April 18, 1984

ADDITIONAL INFORMATION REQUESTED
by the
U.S. Nuclear Regulatory Commission
In Their February 1984
Emergency Plan Review
of the
Pennsylvania State University
Research Reactor

Docket No. 50-5
License No. R-2

April 1984

Fig. 2. PSBR and Local Surroundings

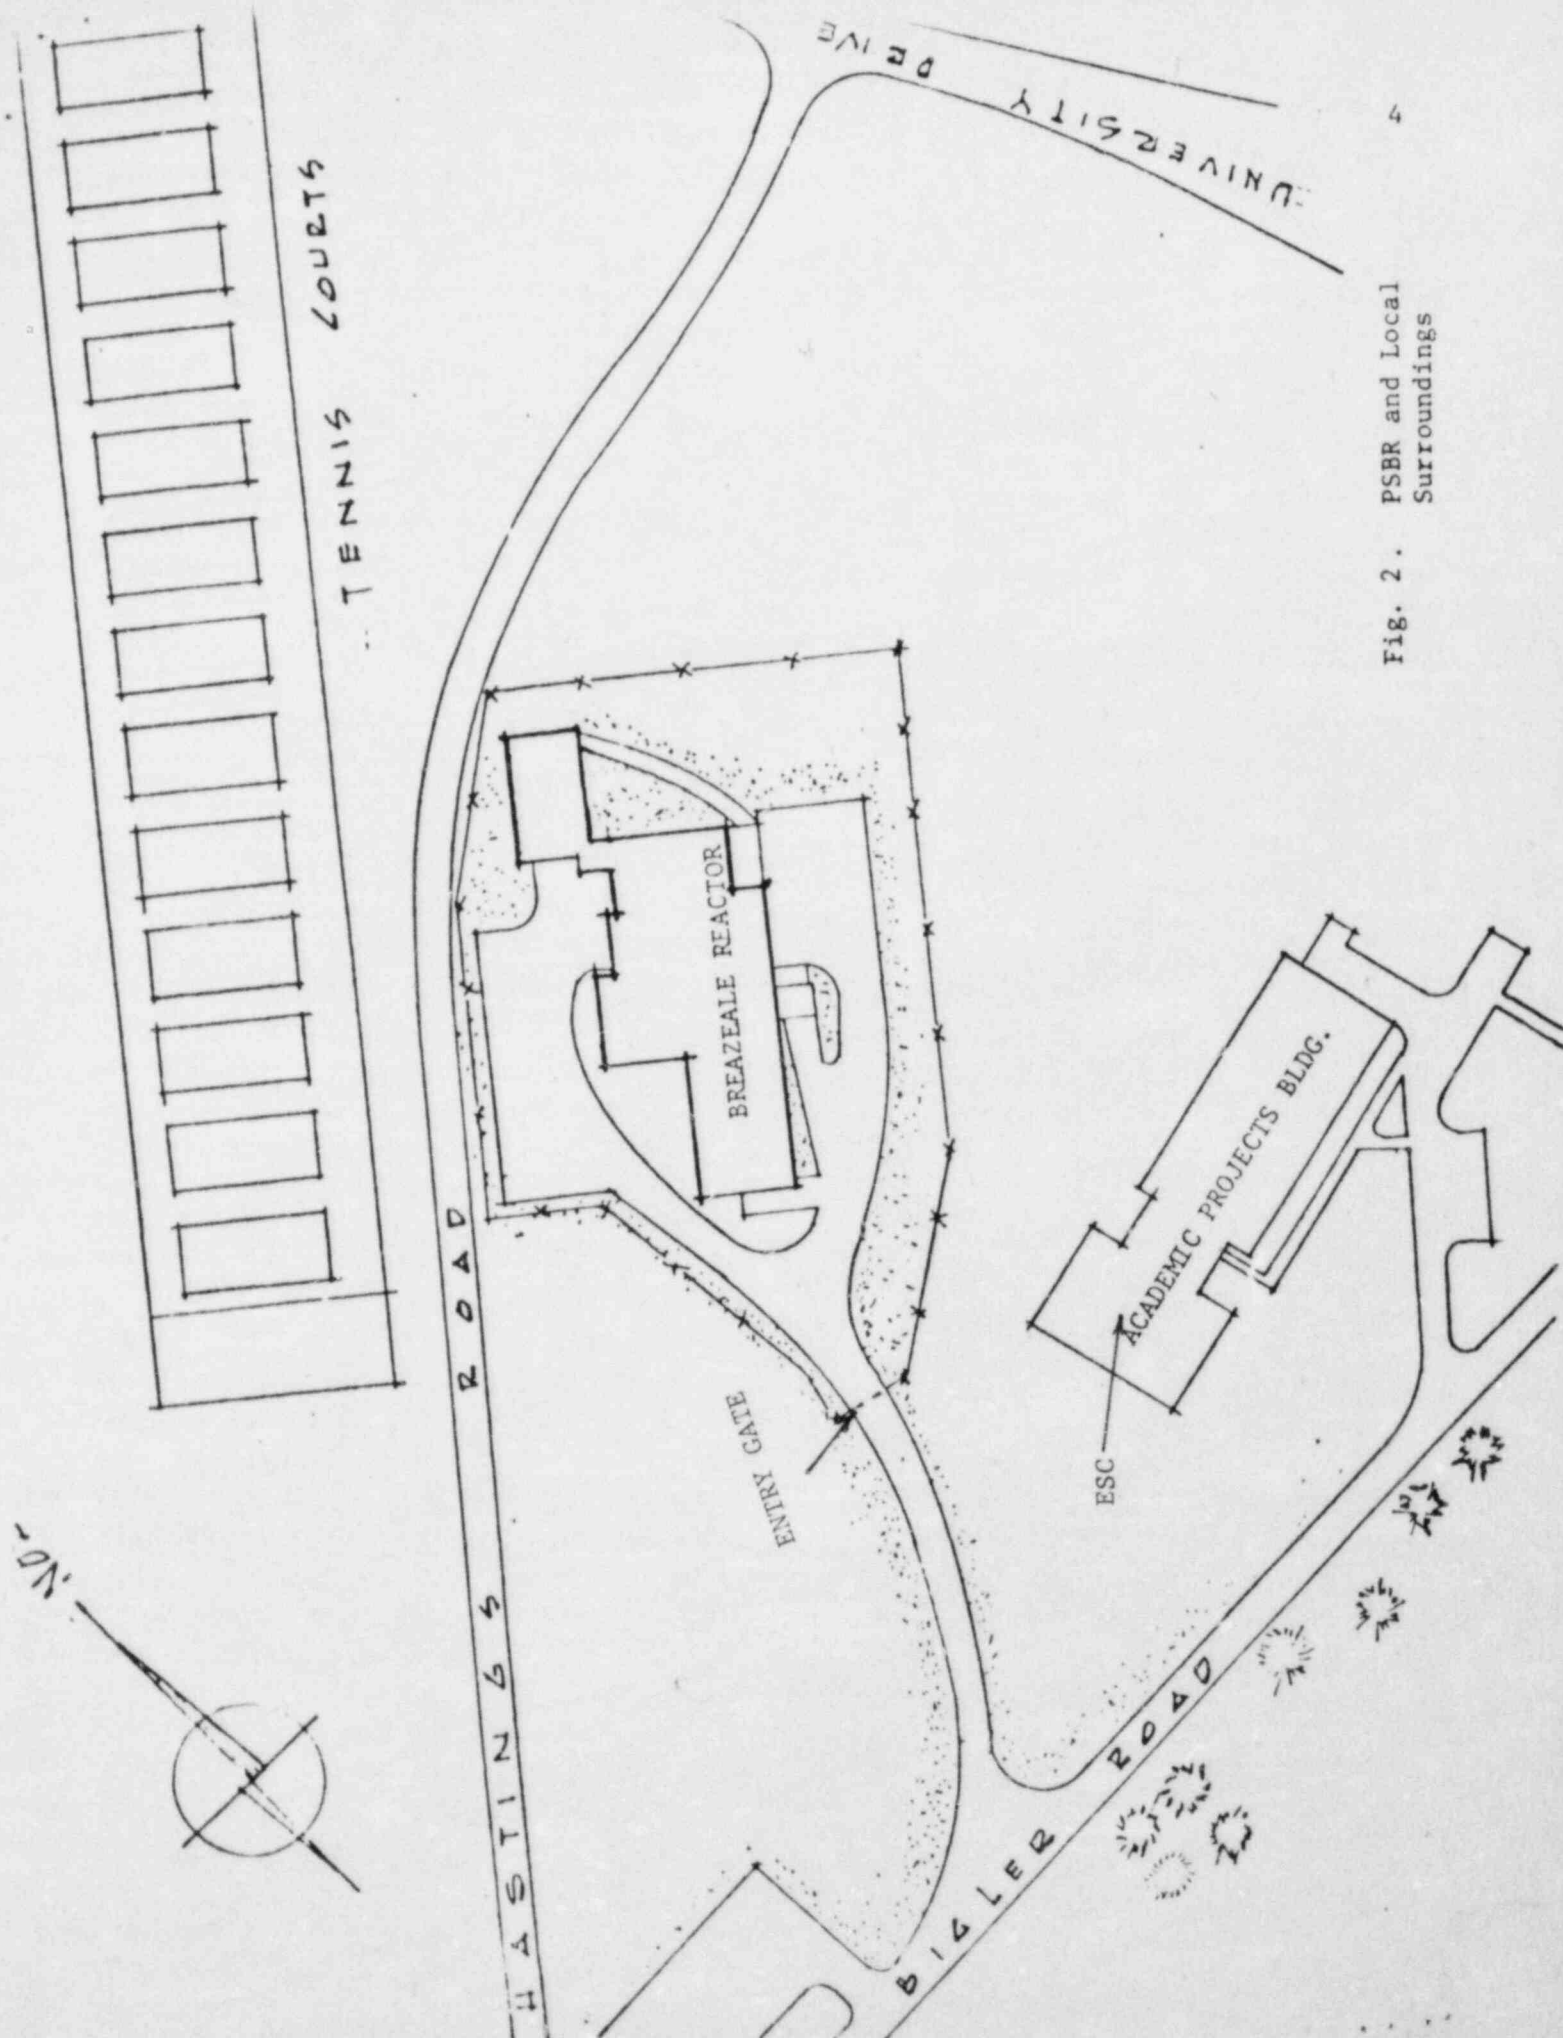
2. Identify the location of assembly areas and specify the methods to be used to assure personnel accountability and segregation of potentially contaminated personnel.

Events that require evacuation of the facility are described in our Emergency Procedures. These procedures require evacuation to the entry gate at the chain-link fence at the reactor site boundary (see Section 2.1 Reactor Site Boundary and attached Fig. 2 of the Emergency Plan). Under normal conditions, personnel from the reactor assemble at the entry gate; however, if weather conditions are bad and when the Emergency Plan is activated, the Emergency Support Center becomes the assembly area. Personnel accountability methods are to be described in our procedures. The question of segregation of potentially contaminated personnel is addressed in 7.3 Corrective Actions. The accountability will be determined by visual observation and/or roll call. Accountability of visitors to the facility is the responsibility of their tour guides and escorts. We have changed our plan to read as follows:

The reactor site boundary is that boundary defined by the chain-link fence surrounding The Pennsylvania State University Breazeale Reactor (PSBR) as shown in Figure 2. Entrance to the boundary is through the entry gate only, which can be locked or used as a control point for entry into the area. The reactor administration has direct authority over all activities within this boundary. The area within the site boundary is available to people not acquainted with the reactor operation.

The Emergency Support Center (ESC) is a fenced-in area within Room 117 in the Academic Projects Building (see Fig. 2). This room is used by the Emergency Director as the operation center for the duration of the Emergency and as the assembly area for personnel from the reactor during the emergency. It also contains additional emergency supplies and equipment for use during the emergency.
